Solicitation Addendum

Addendum No.: 1
Solicitation No.: 18-R068073DW
Project No.: N/A
Solicitation Title: Furnish and Install an Erosion Control System
Addendum Date: 2/9/2018
Procurement Contact: Dennis W. Wallace, Contract Manager

PROPOSED LOCATION OF "CONCRETE CLOTH MAT- MILLIKEN CC5)

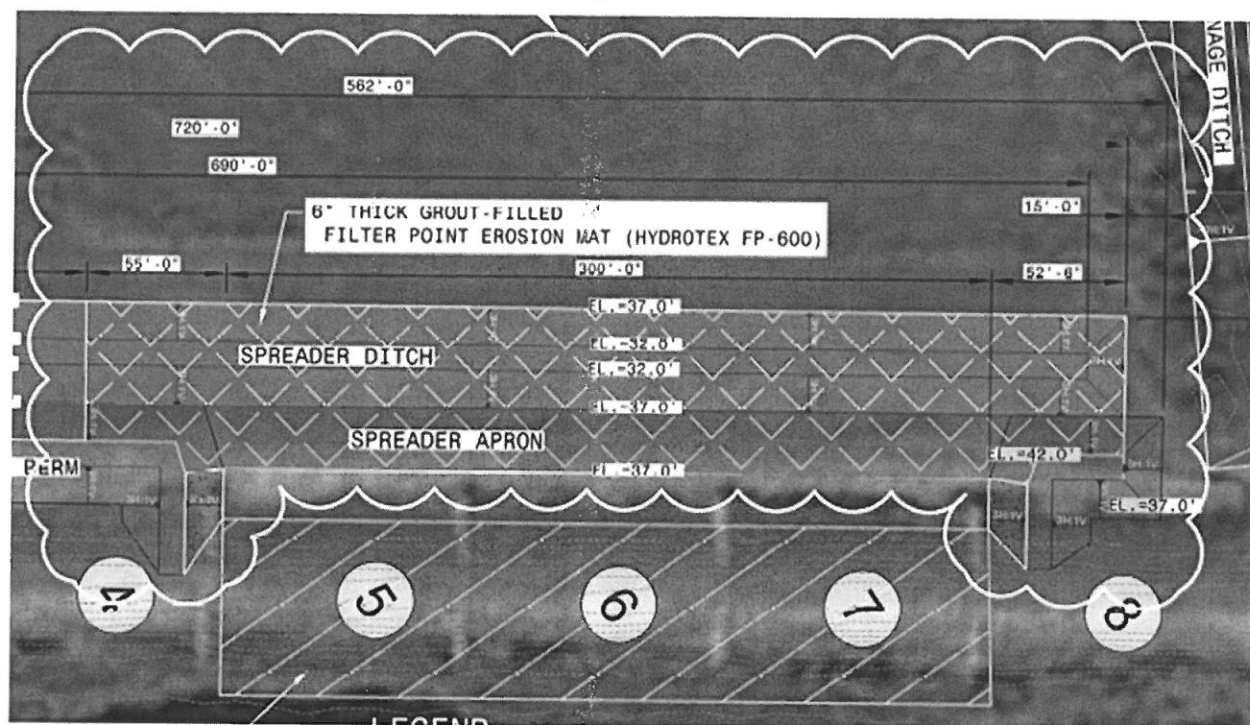
Q21. Noted on the Bid Form: 'C' - Erosion Concrete Cloth Mat - Milliken CC8, and # '6' - Spreader Ditch S.Y. 207. I cannot find this on the plans. Is this still part of the project? If so, can Manatee County be more specific as to where it is to be installed?

R21. The "Concrete Cloth Mat" is Milliken CC5. There is some TYPO within the plans and bid package. The below figure is a close-up location of the proposed "Concrete Cloth Mat – Milliken CC5 in the vicinity of Spreader Ditch and is shown in the revised plans.
